Application No: BC09/108312
Related Pim Application No: PIM09/108298

Residential/Farm - partial demolition and add bedroom, laundry, WC and kitchen extension to dwelling

AMENDMENT
09-290610

- 1a. Building consent number **BC 09/10 8312**
- 1b. Site address
39 Belt Road
New pLymouth
- 1c. Reason for amendment
☒ Change by owner
☐ Other, please specify
☐ Information request by Council

- Confirm all door and windows with owner prior to construction
- Refer to Elevations for openings

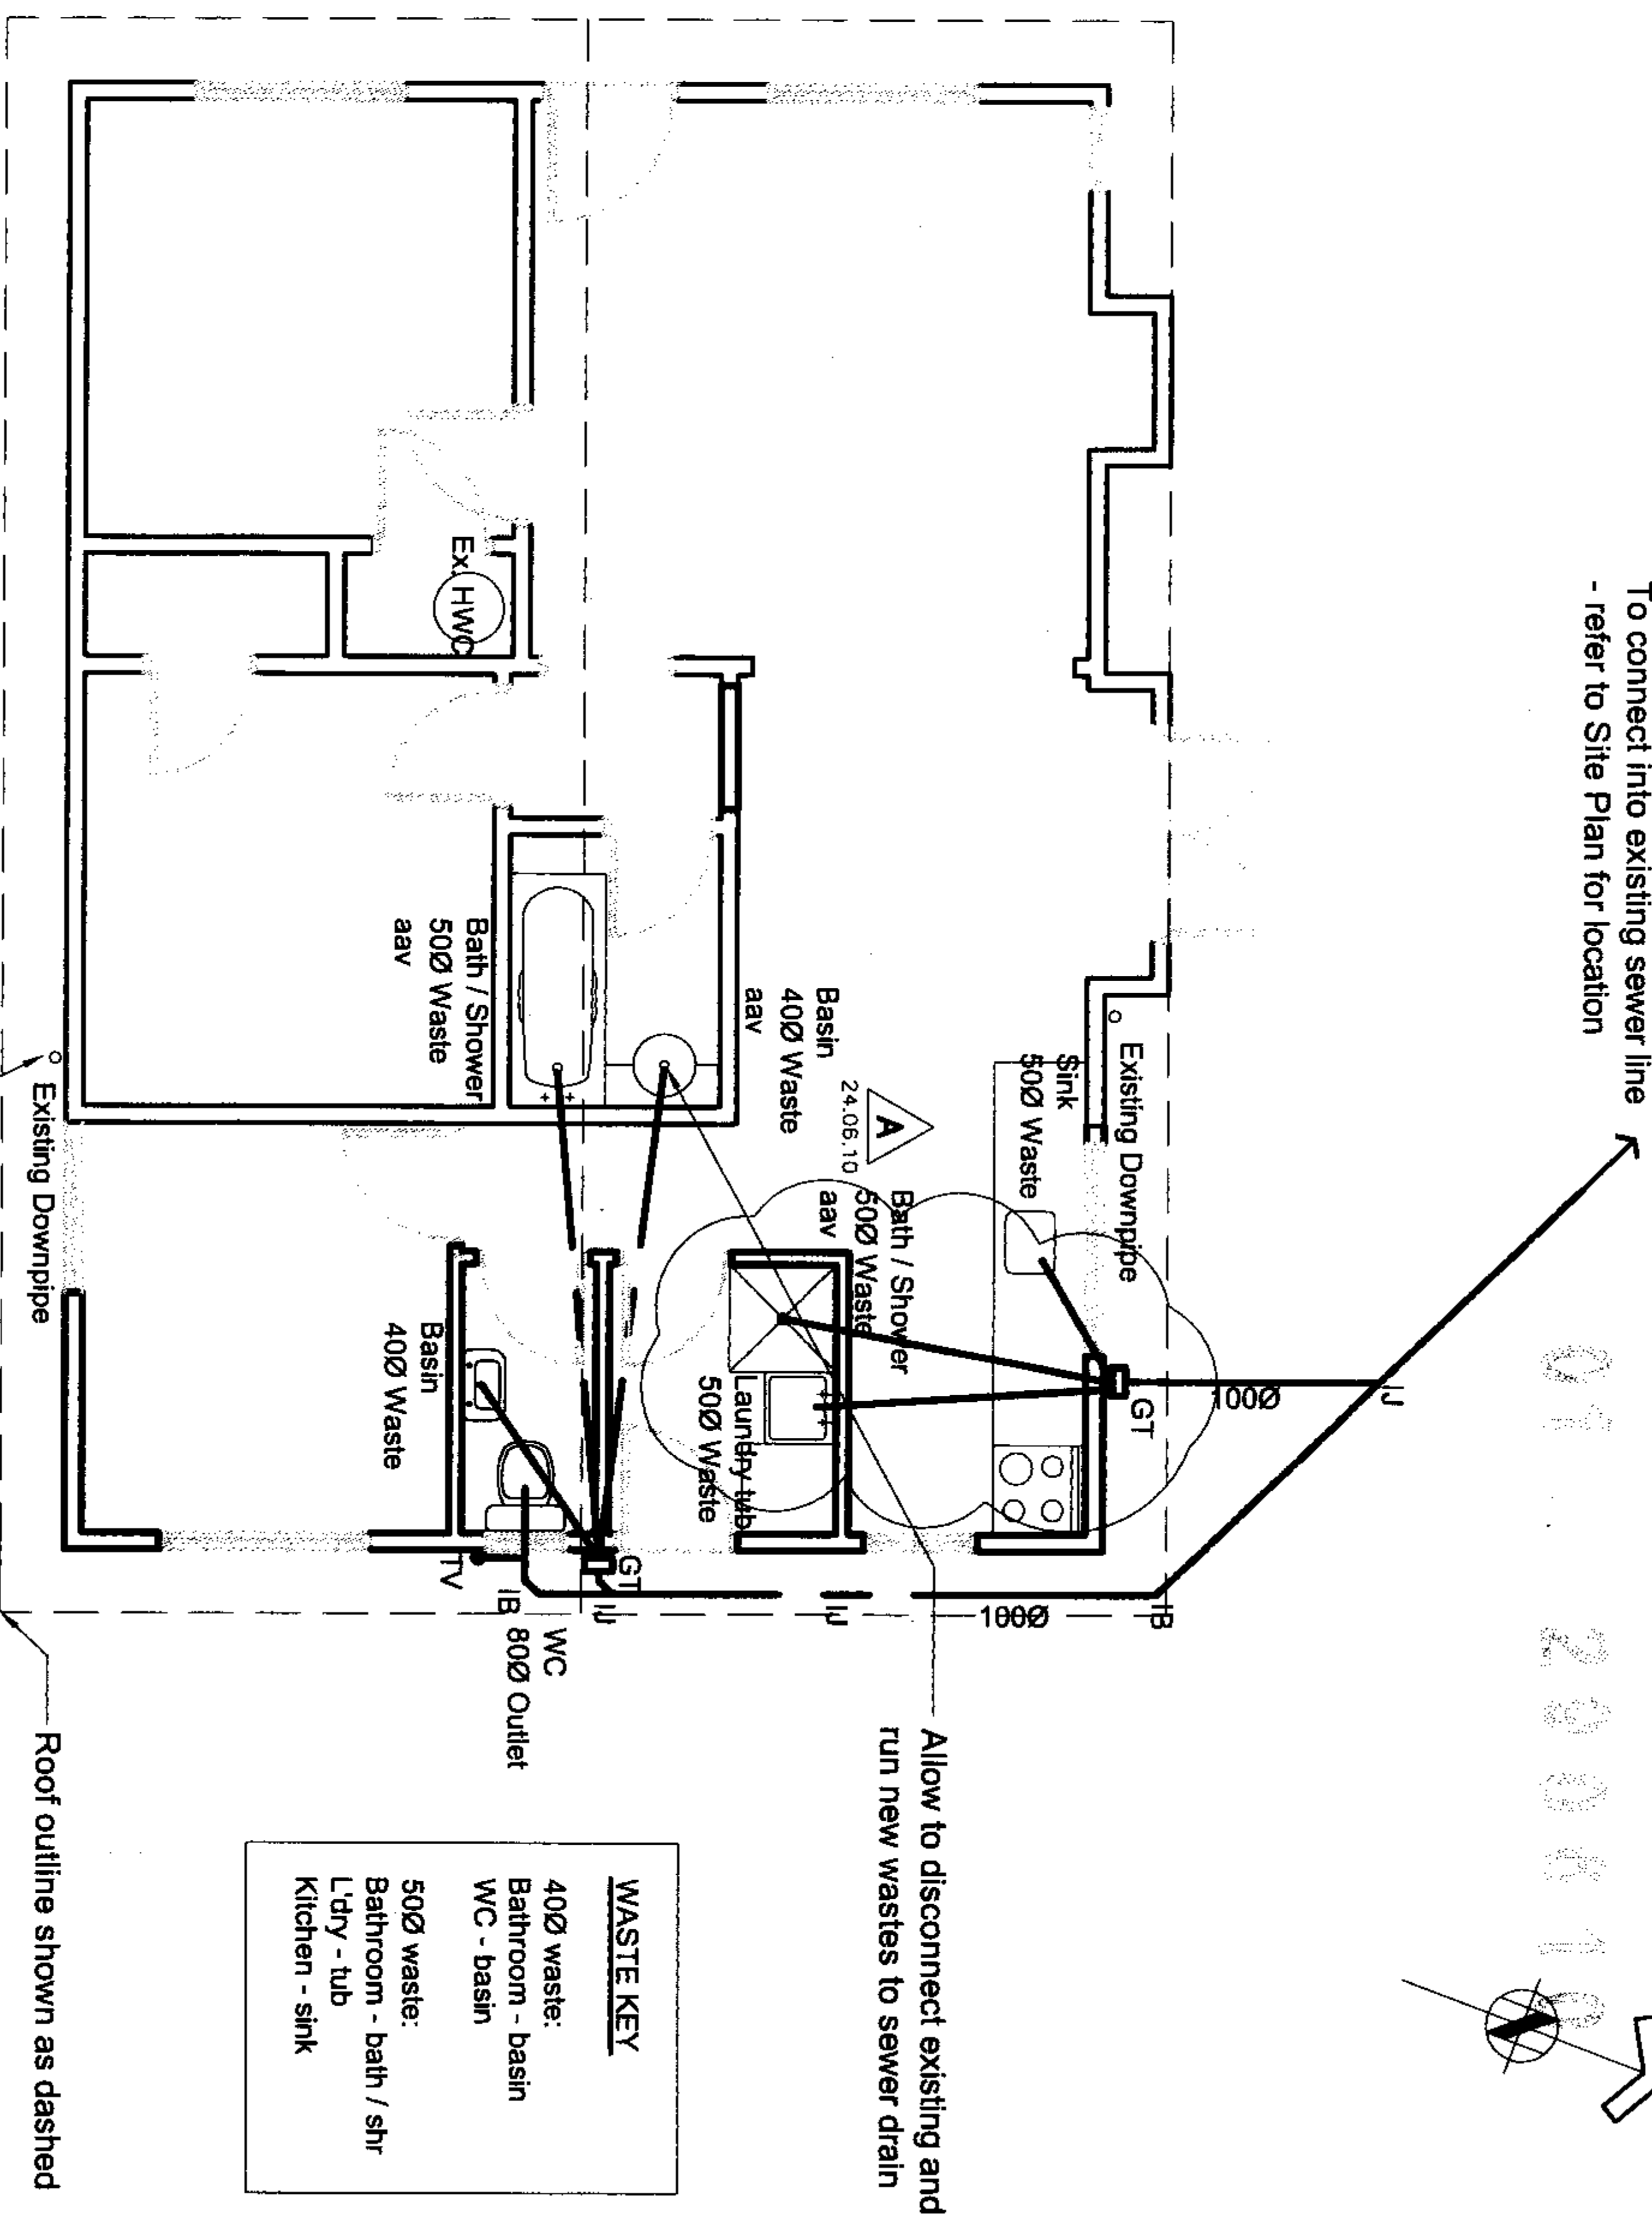
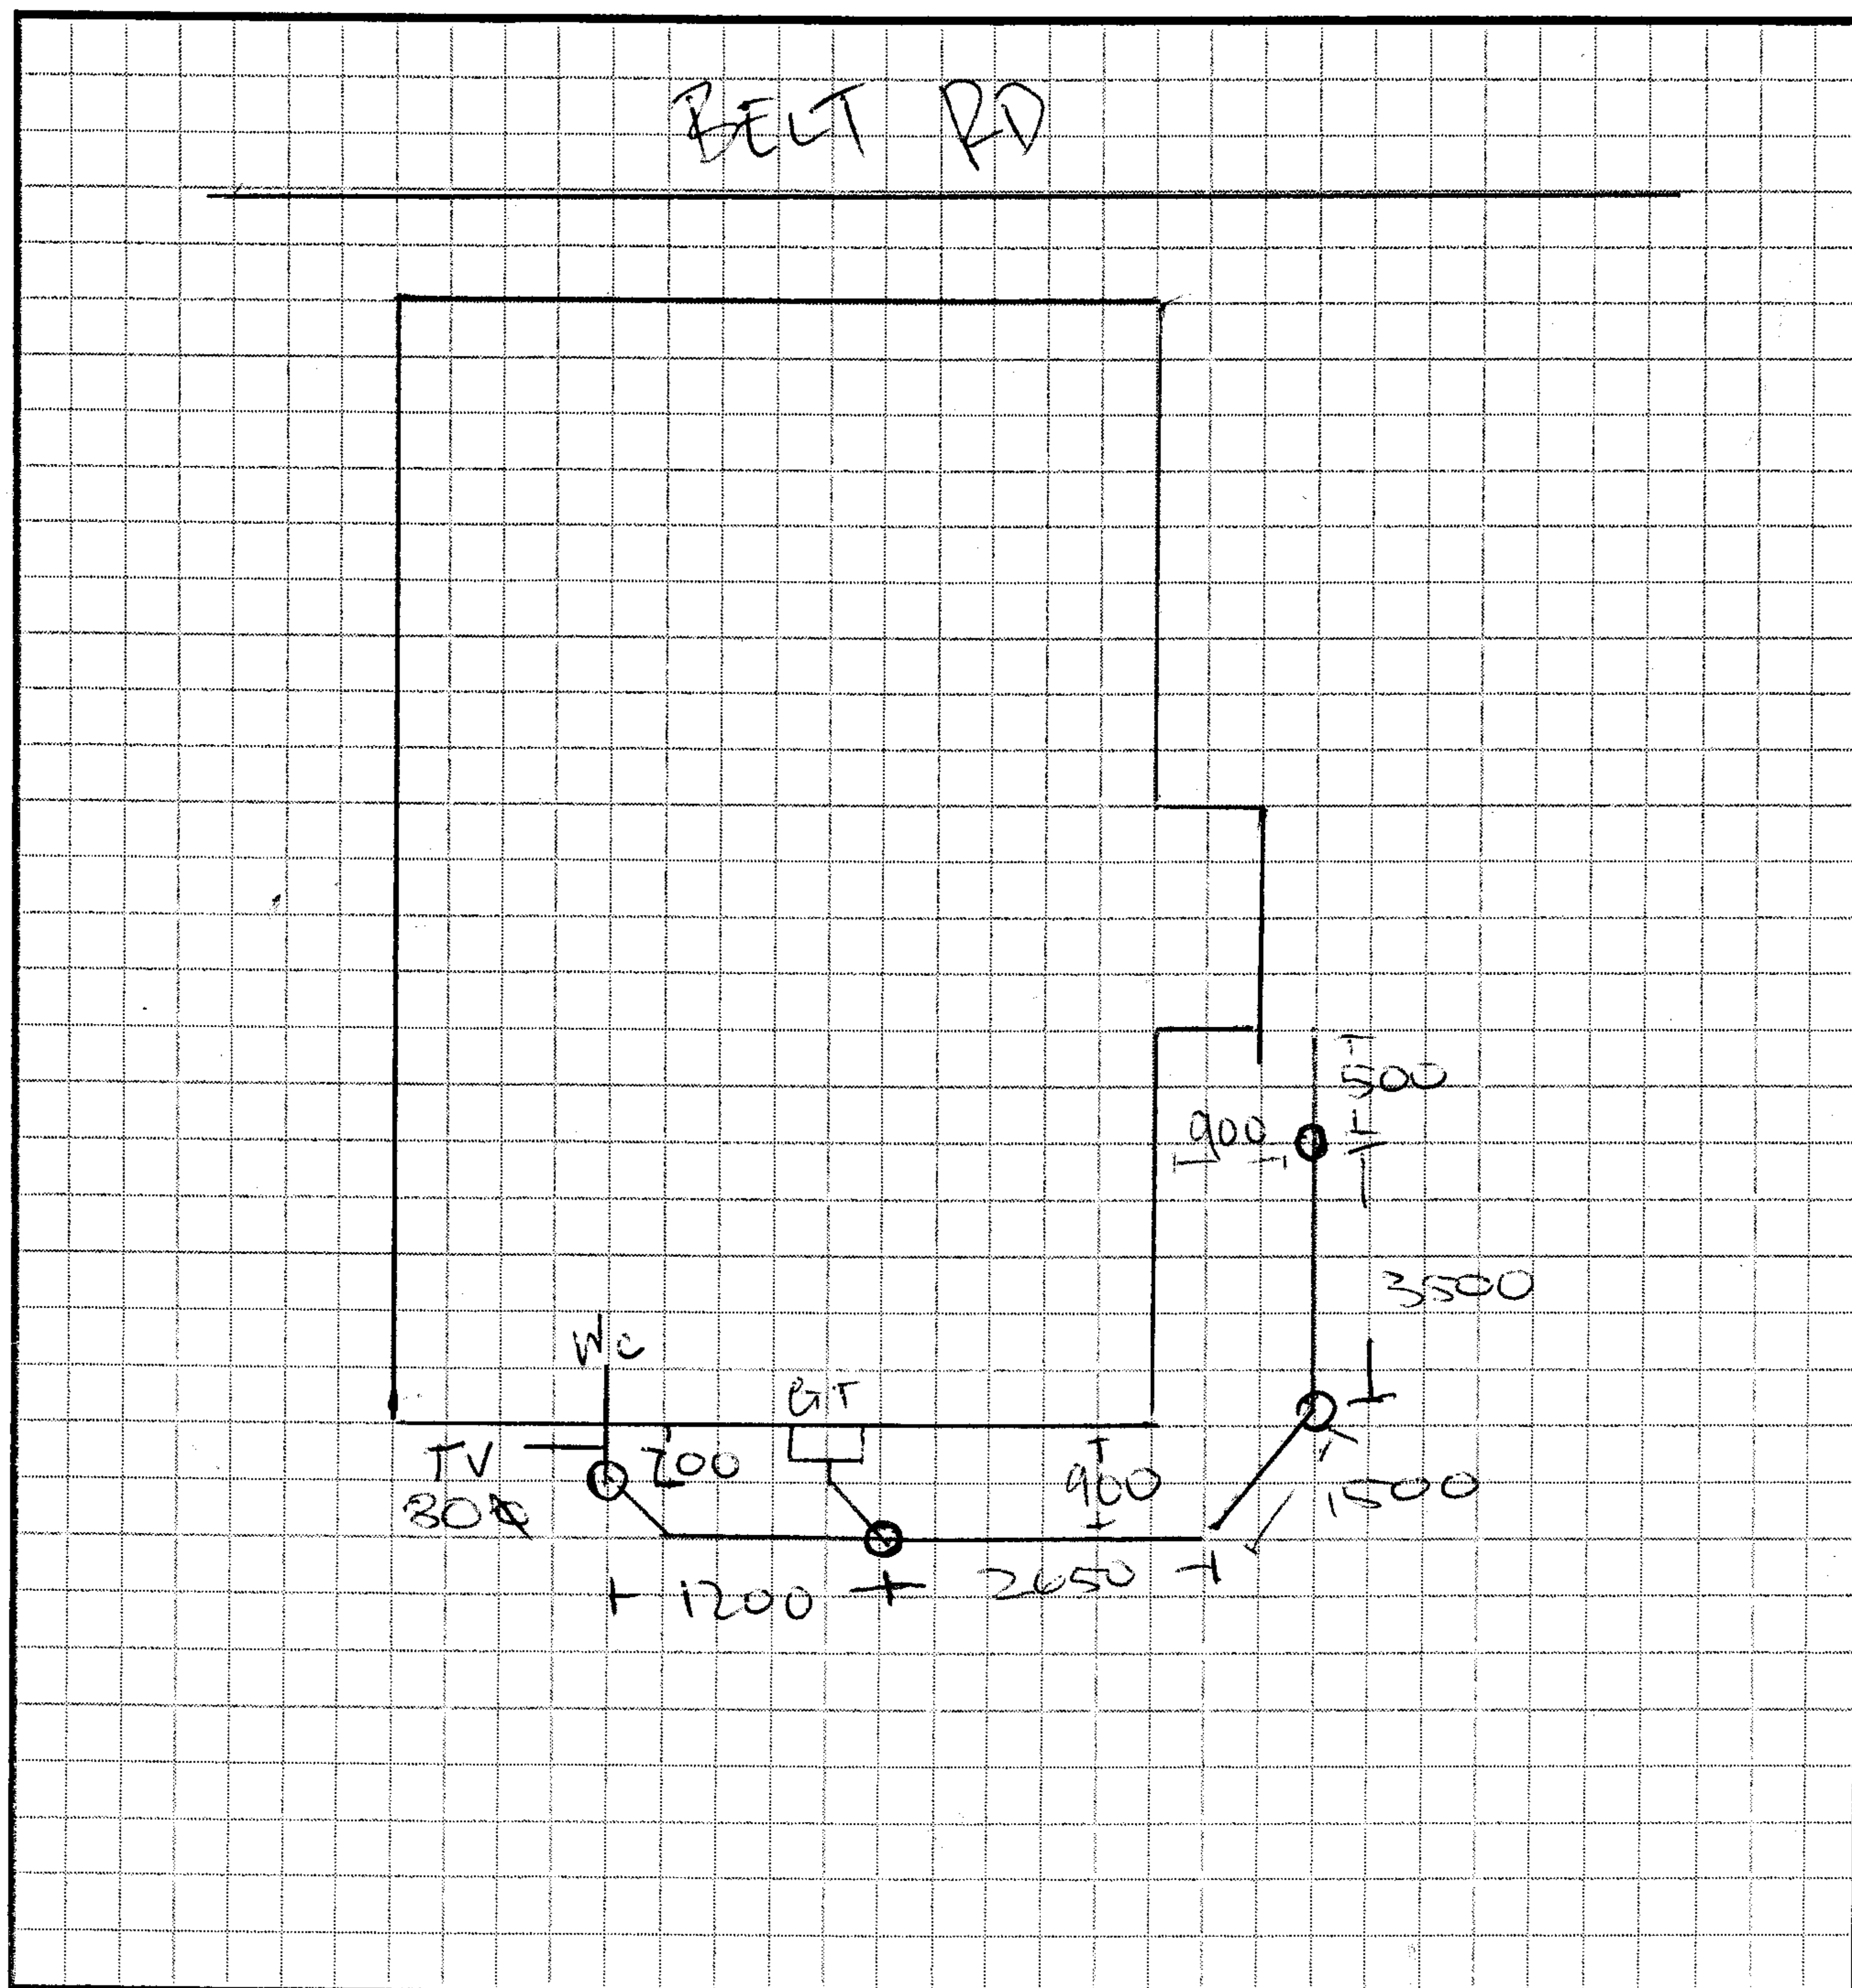
A2-1	A2-1	Shower & W5 added, Plumbing, floor plan, & piles amended

REVISION:	
A	Shower added
	W5 added
	Plumbing amended
	Floor Plan amended
	New row of piles added
	24.06.10
